Statement No: 962

**STATEMENT TO AMEND CONDITIONS APPLYING TO A PROPOSAL
(PURSUANT TO THE PROVISIONS OF SECTION 46 OF THE
ENVIRONMENTAL PROTECTION ACT 1986)**

Cloudbreak Life of Mine Project

Figure 2 Locations of monitoring bores within the Project Area

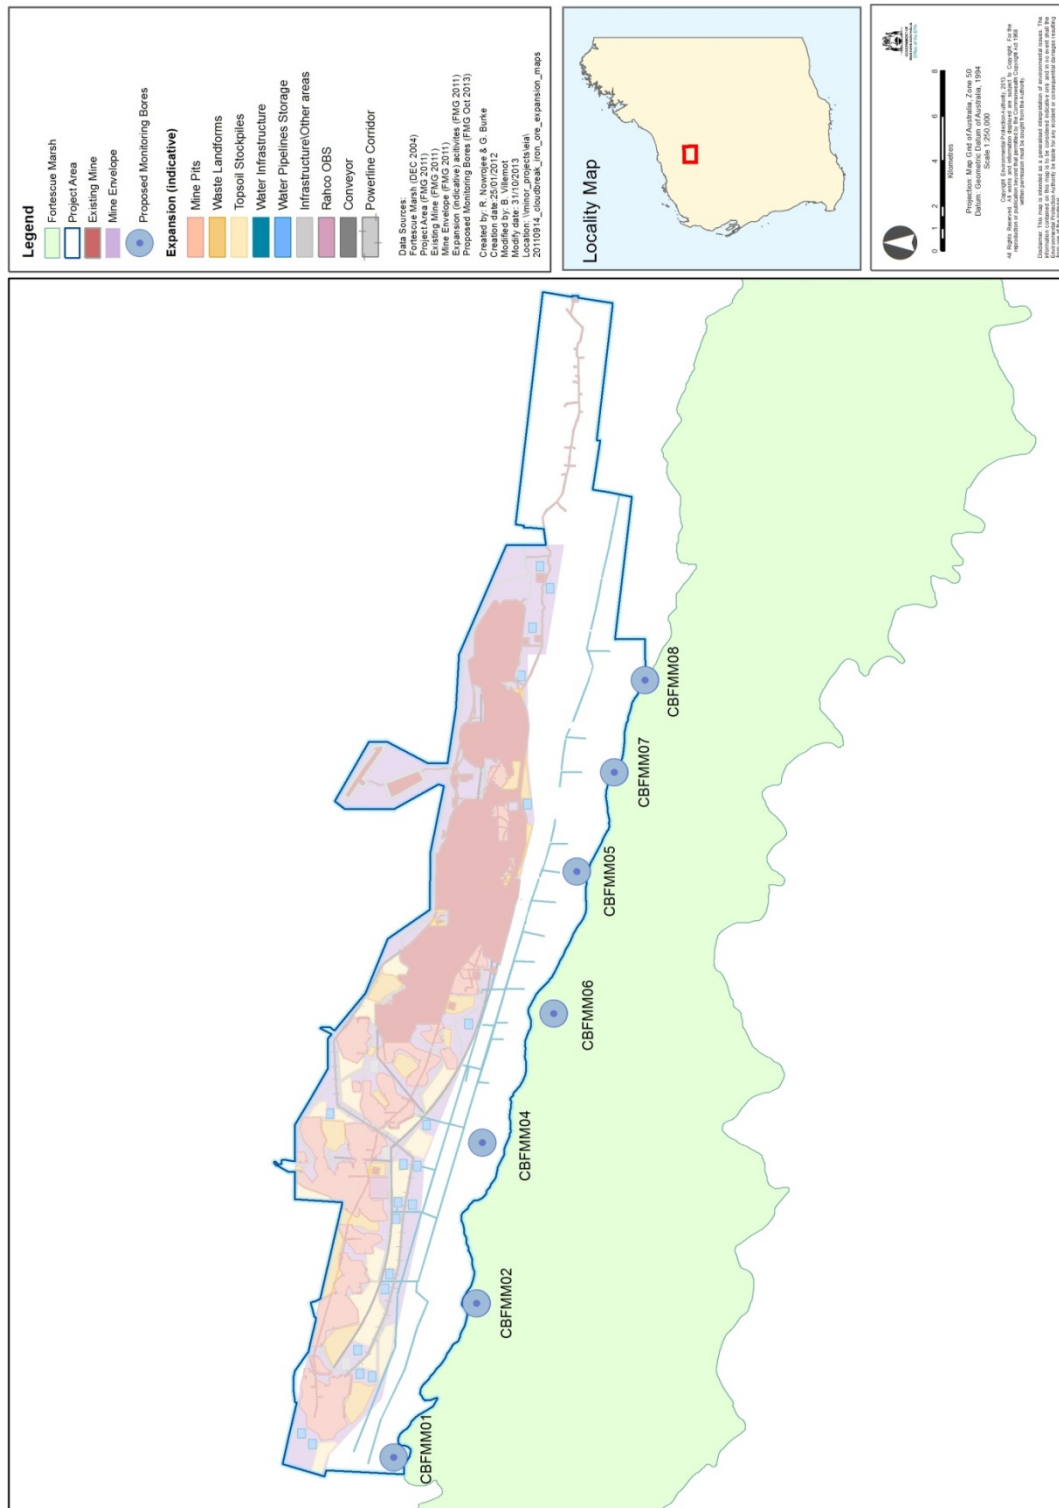
3. Change to Schedule 1

Replace Figure 2 with figure showing new monitoring bores below
